Staff Report to the Western Weber Planning Commission

Application Request:	Consideration and action on a request for final approval of Winston Park Cluster Subdivision.
Type of Decision:	Administrative
Agenda Date:	Tuesday, June 13, 2017
Applicant:	Jaymak Ogden, LLC
File Number:	LVW040717

The applicant has submitted a request for final approval of the Winston Park Cluster Subdivision, a cluster subdivision consisting of 54 building lots, 17 open space parcels, and 3 common areas. The Winston Park Cluster Subdivision is separated into 2 phases on one subdivision plat, both of which are being presented for final approval as part of the same application. The proposed subdivision is located at approximately 3701 West 1800 South, Ogden, UT and is in the A-1 zone. Public roads will be created with this proposal to provide access to each lot and the design will create connectivity to the surrounding area for future development.

WINSTON PARK SUBDIVISION
CLUSTER SUBDIVISION

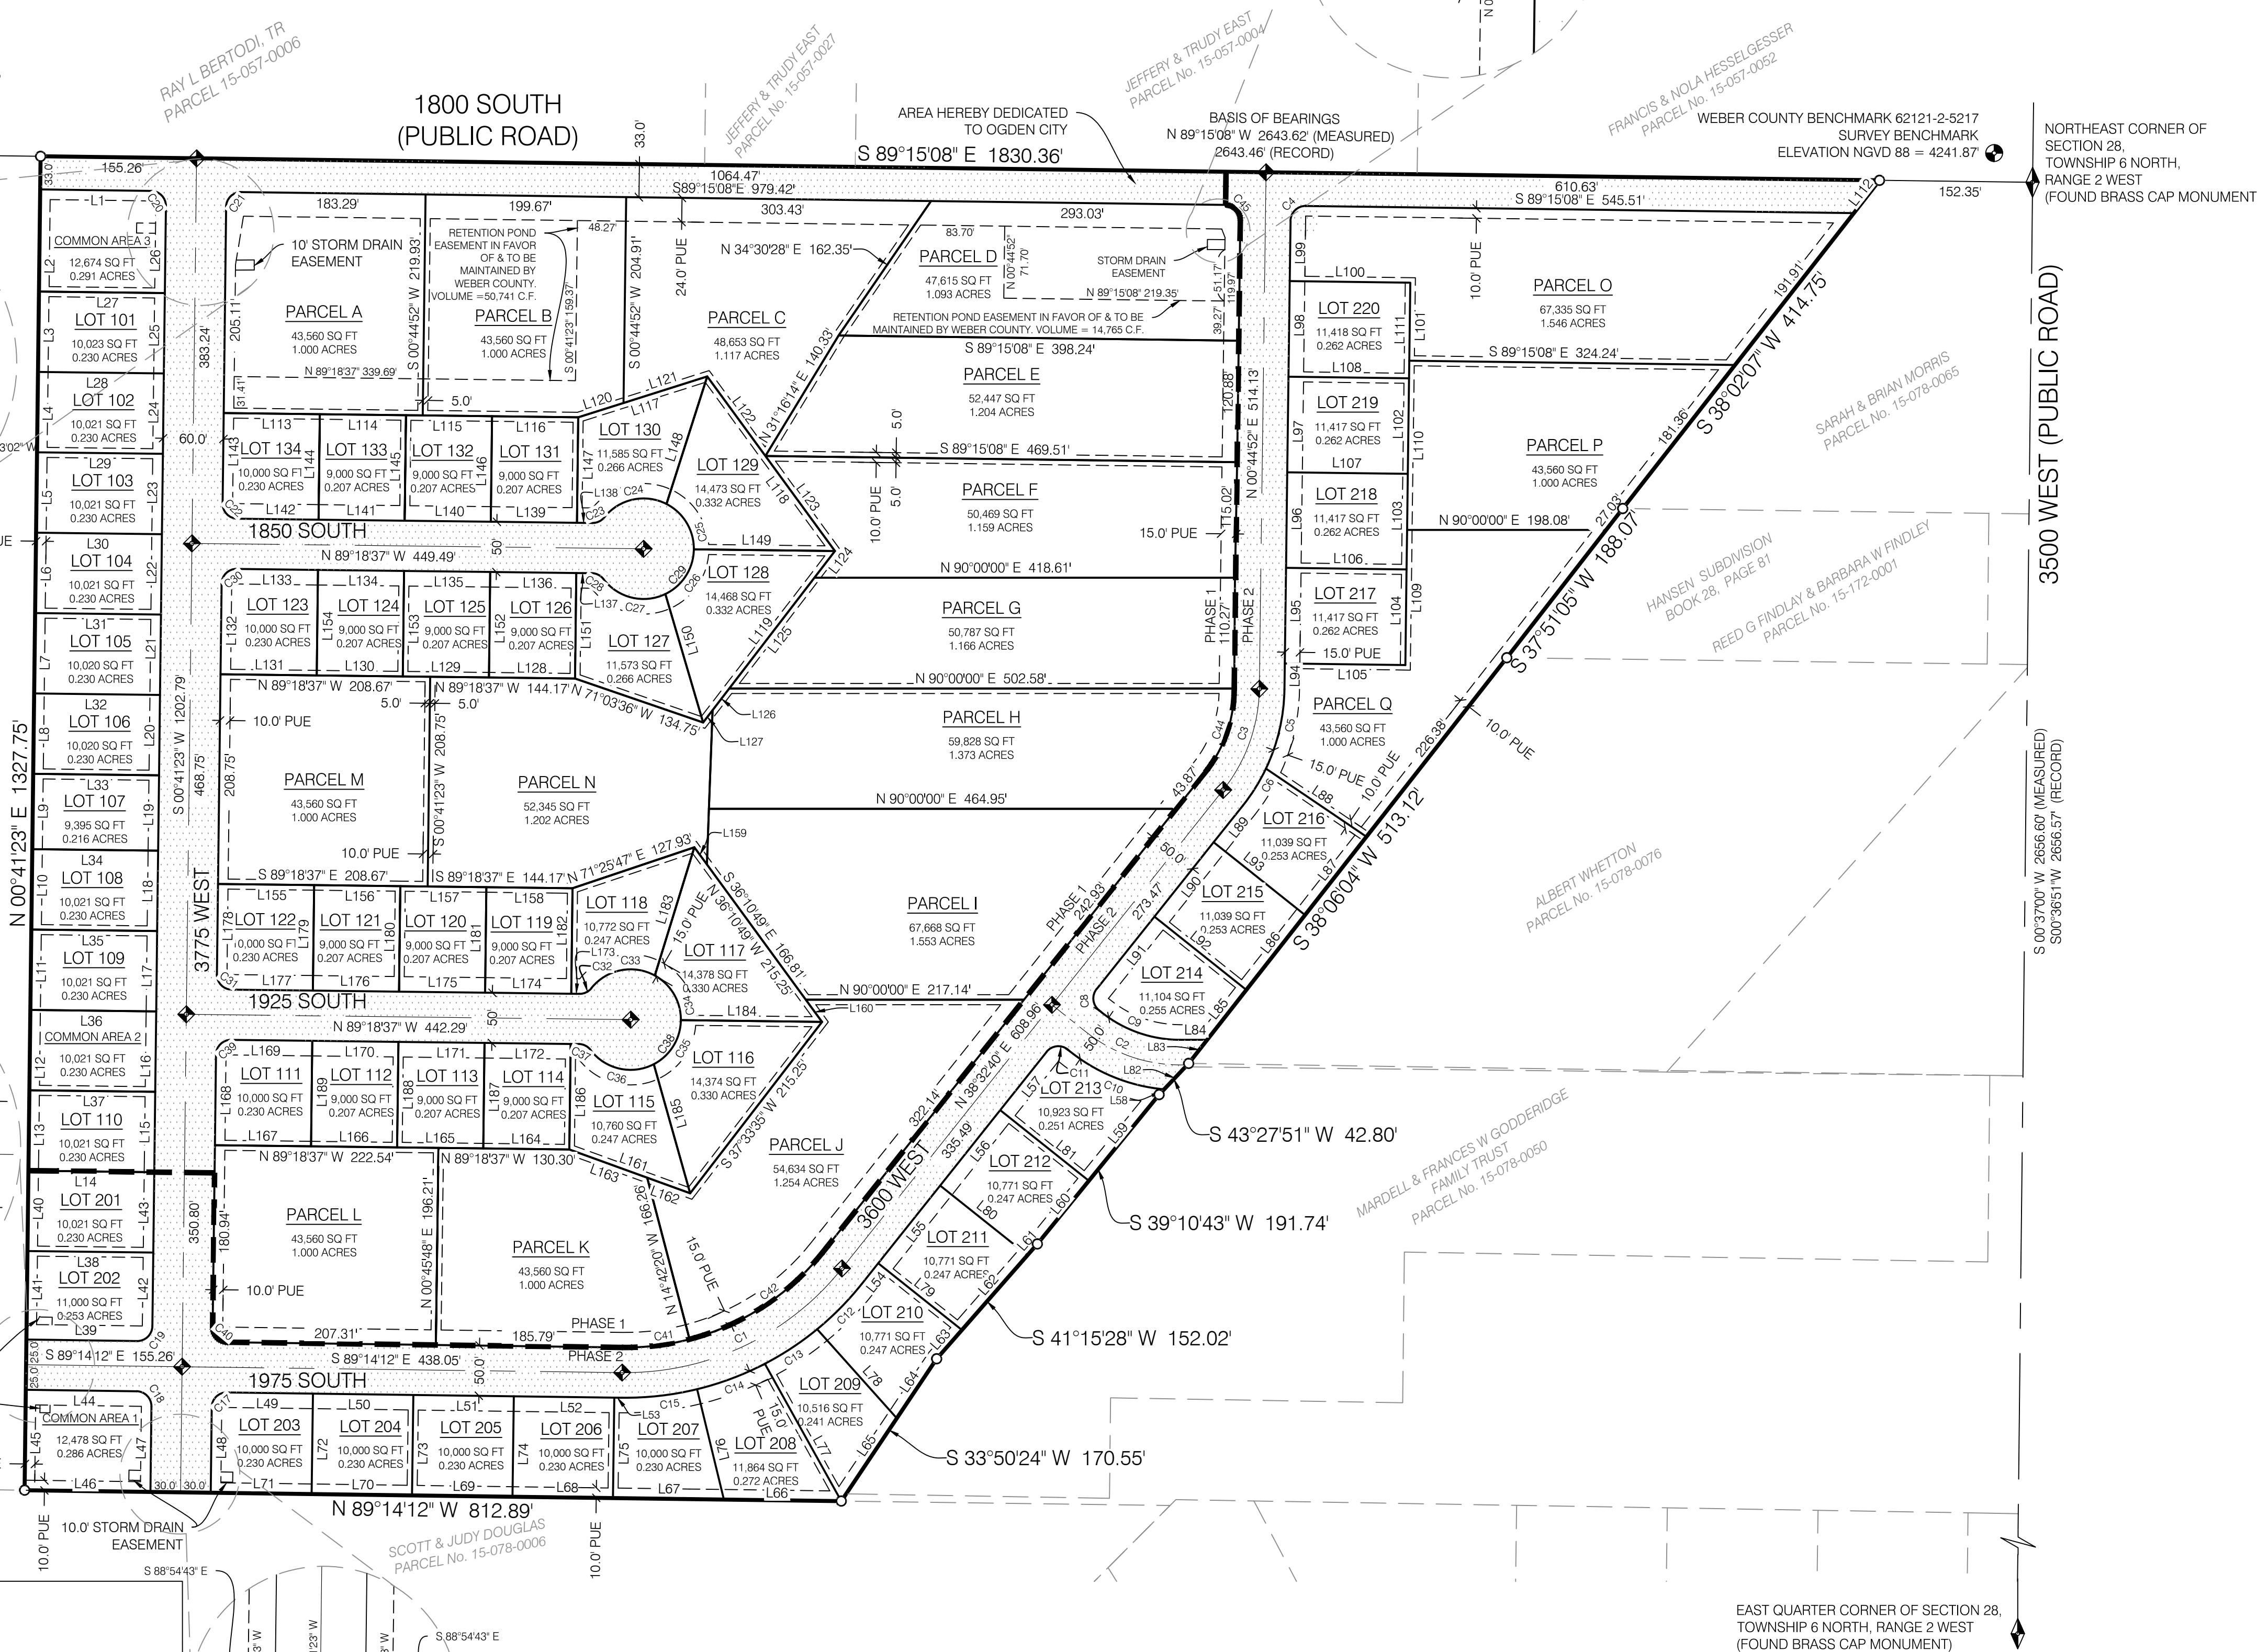
Cluster subdivisions, in accordance with the LUC, are permitted in the A-1 Zone. As stated on the final plat, the subdivision contains 40.259 acres not including the road area, allowing for 36 building lots at 40,000 square feet, the minimum lot size in the A-1 Zone. The applicant is proposing a 50 percent bonus density to increase the number of building lots by 18, for a total of 54 building lots.

Cluster subdivision design and layout standards: The minimum lot width requirement for cluster subdivision lots in the A-1 zone is 60 feet per LUC§ 108-3-7(2)(c). The proposed cluster subdivision meets the lot width as well as the open space width requirements outlined in LUC §108-3-4 (1) which state:

The proposed subdivision consists of open space areas between clusters of lots that are a minimum of 80 feet wide and the open space areas in between lots and exterior boundaries are a minimum of 125 feet wide.

The proposed cluster subdivision consists of 54 building lots and each cluster of lots consists of less than one third the total number of lots in the subdivision, complying with LUC § 108-3-4 (2).

The proposed lot sizes vary from 9,000 square feet to 14,473 square feet. The minimum lot based on meeting the criteria outlined in LUC-§ 108-3-7 which states:

The proposed cluster subdivision is adjacent to multiple undeveloped parcels in all directions of the current parcel's boundaries, meeting the requirement to reduce lot size to 6,000 square feet. All lots within the proposed cluster subdivision meet the area and width requirements.
